**NOTICE OF MEETING  
of the  
APPEARANCE REVIEW COMMISSION  
OF THE VILLAGE OF WILMETTE**

**Monday, March 7, 2022 at 7:00 P.M.  
Training Room**

#### **2022-AR-05 3200 - 3232 Lake Ave**

#### **Edens Plaza Appearance Review Certificate**

# TYPICAL MASONRY SITE WALL

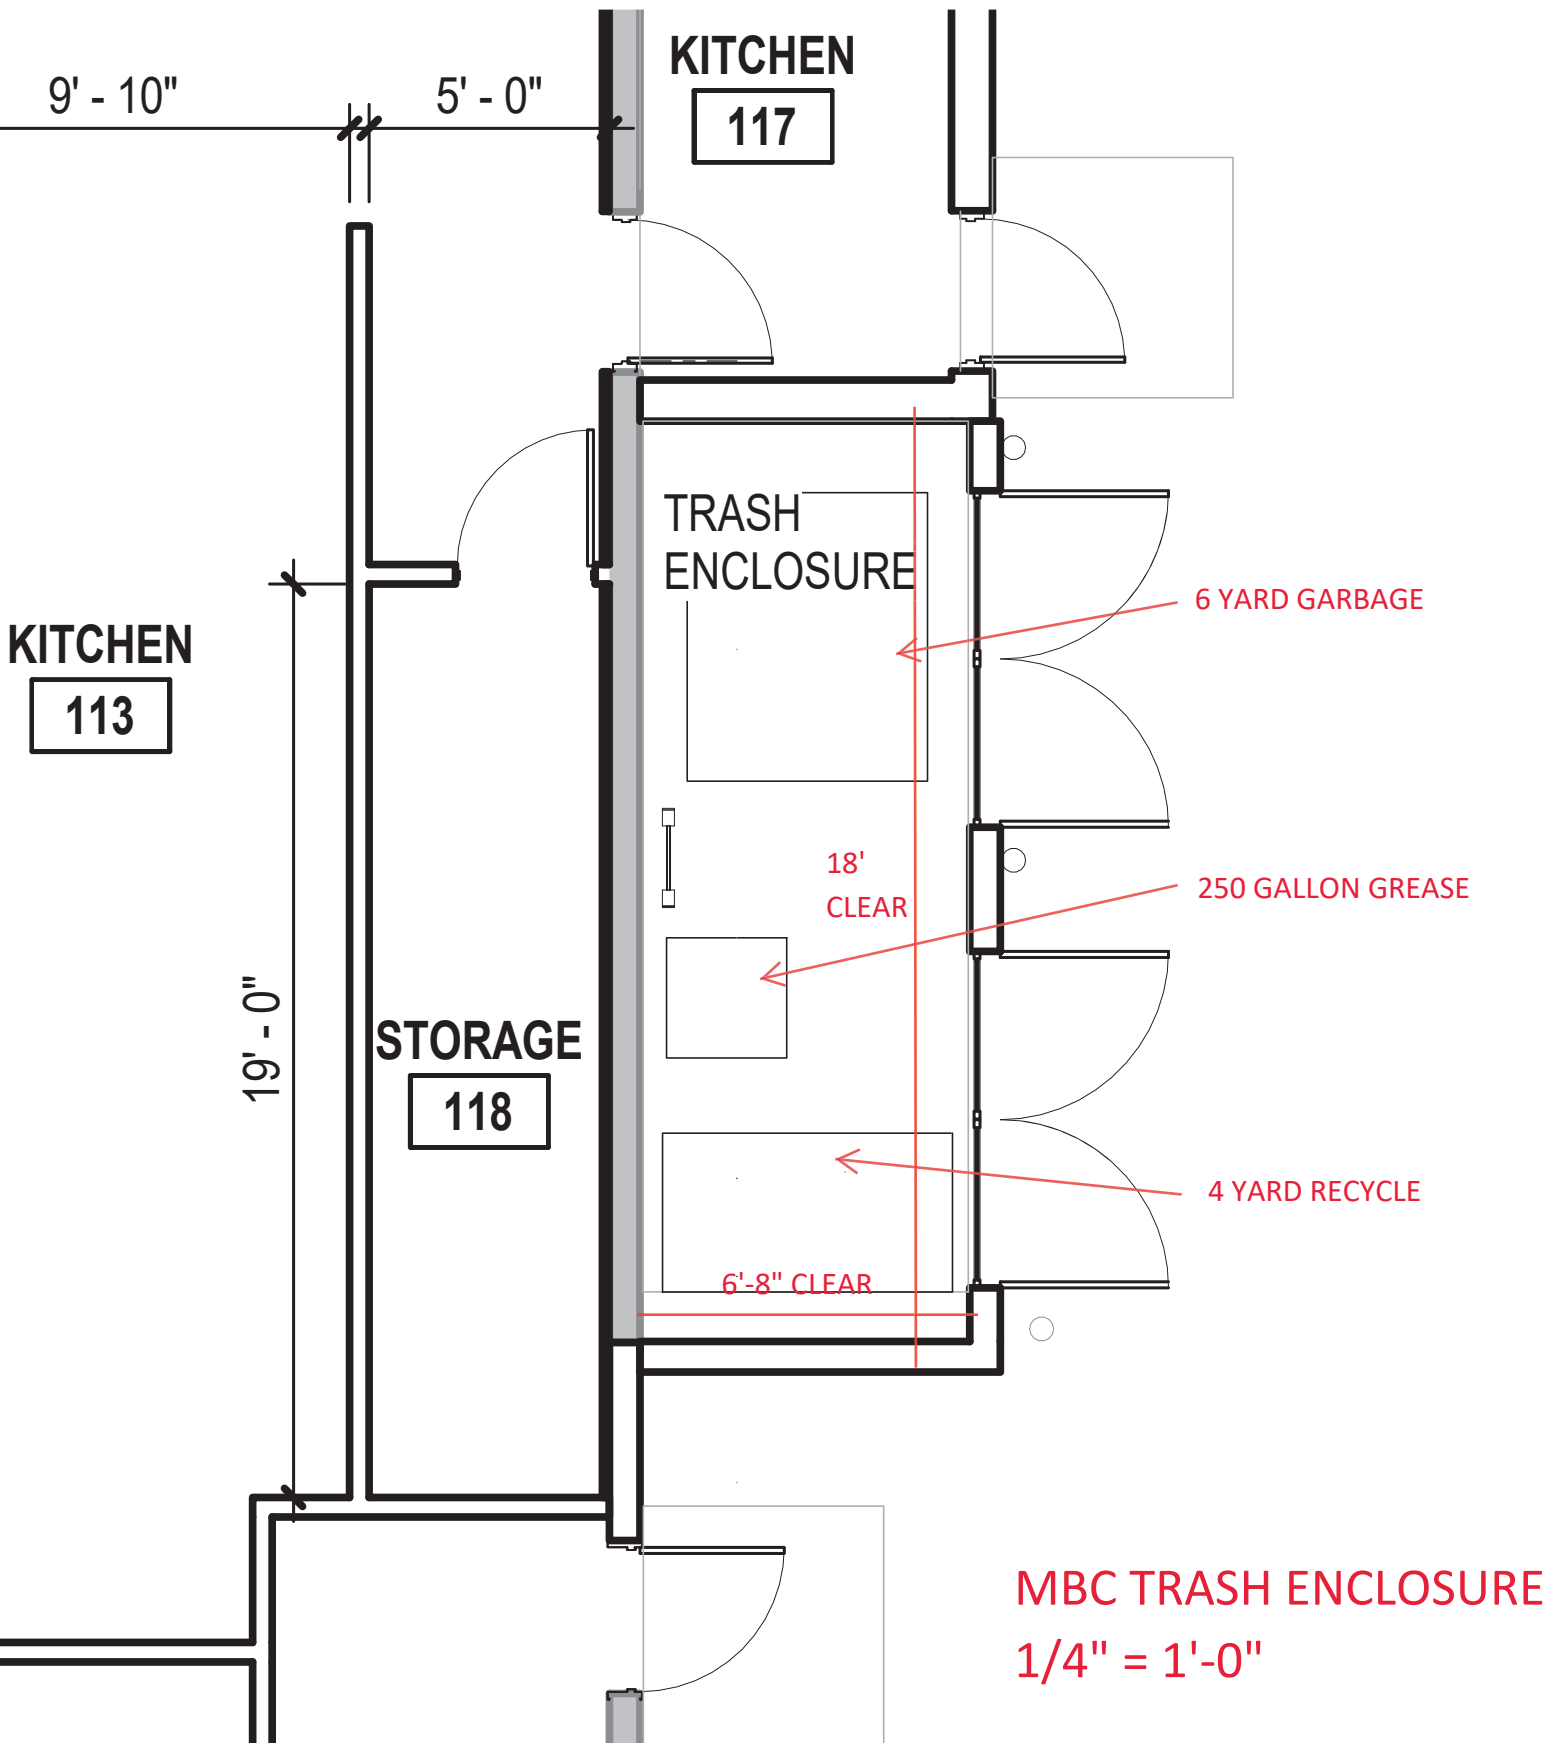
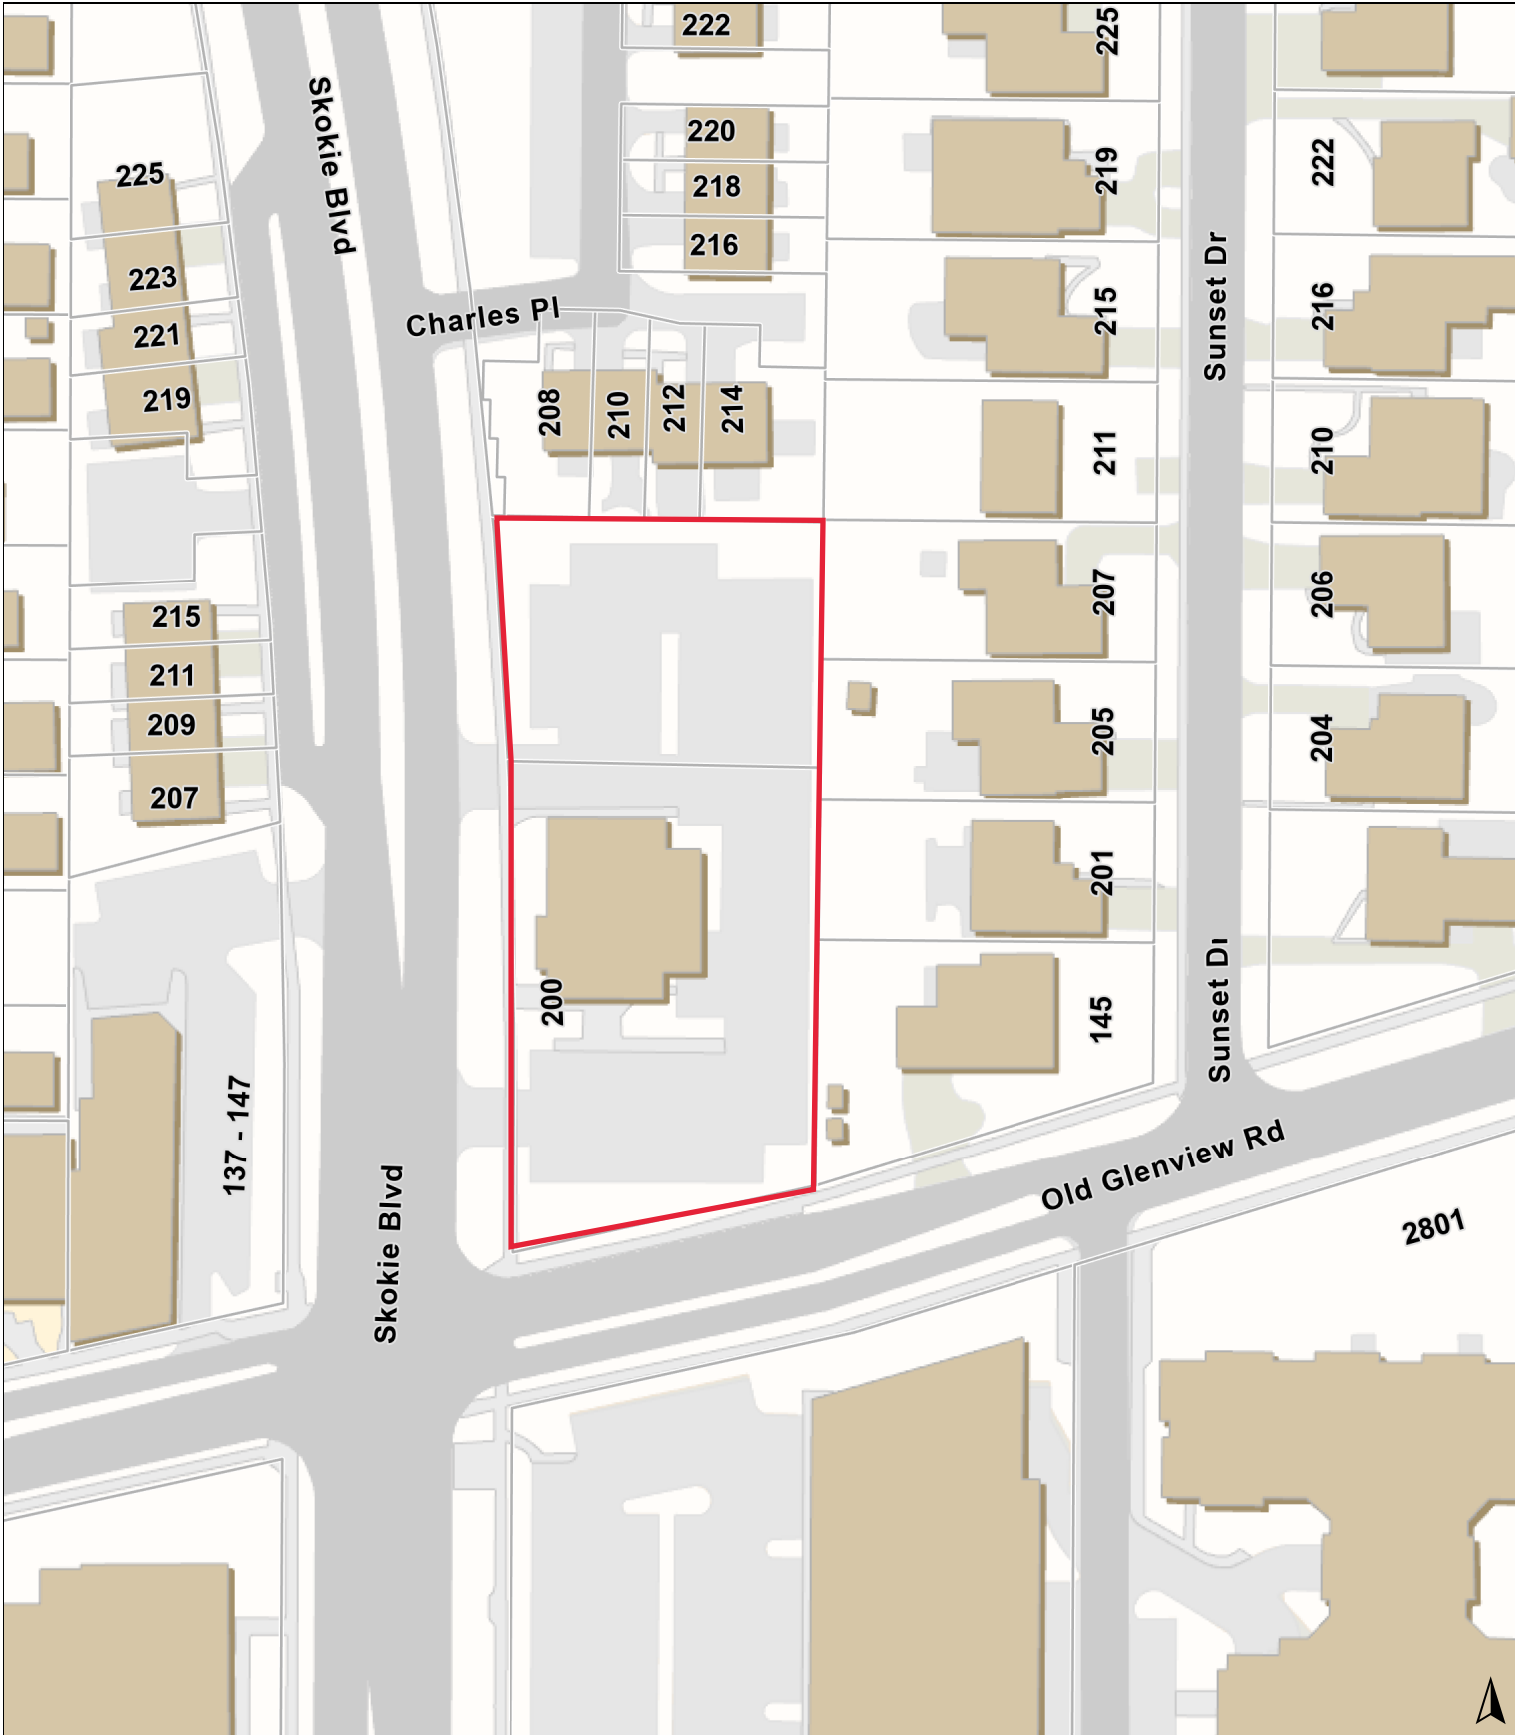
9. Need wall section and finish materials for 24" seat wall along Skokie.  
**Response:** The purpose of this wall is to address the grade change between the existing public walk and the accessible parking / entry walk. Since the existing sidewalk grades cannot be adjusted, this allows the patio area to remain at accessible slope from the parking area to the entry doors. The wall will be constructed of a stacked stone masonry (refer attached image) with a limestone cap. A section through the wall is attached and physical samples will be brought to the March 7 meeting.

1  
A7  
**BUILDING SECTION**  
SCALE: 1/8" = 1'-0"

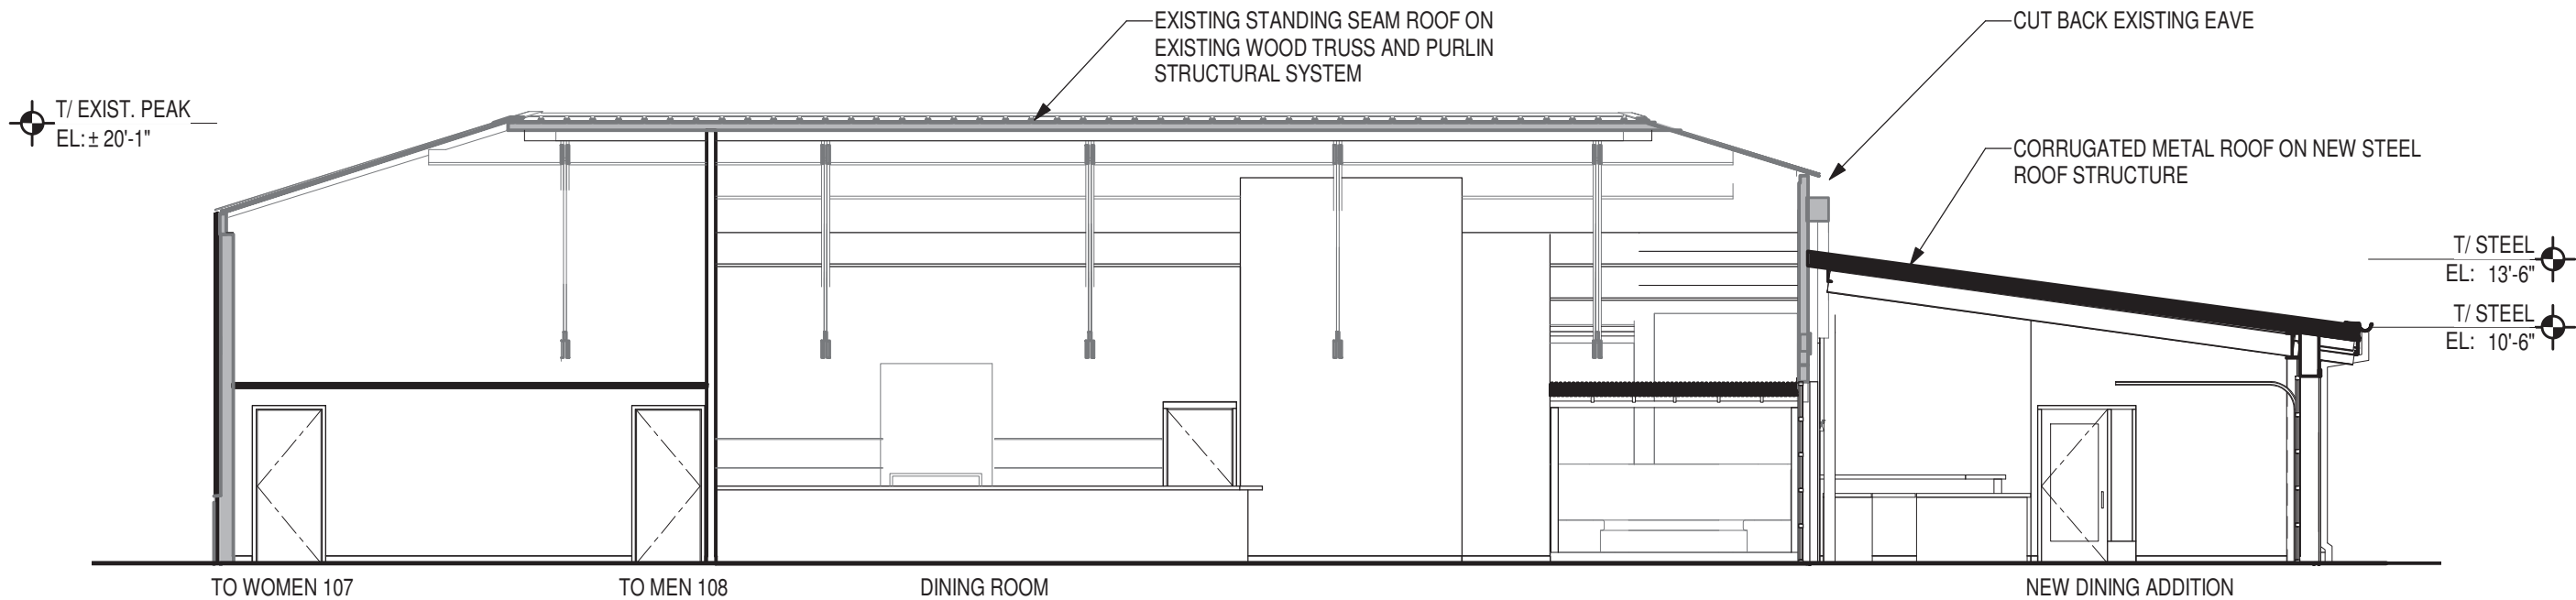
17. Show mechanical equipment on A7 to verify all [will] not exceed height of the parapet.

**Response:** Please refer to updated A7 and equipment cut sheets for heights of equipment in relation to the parapet height.
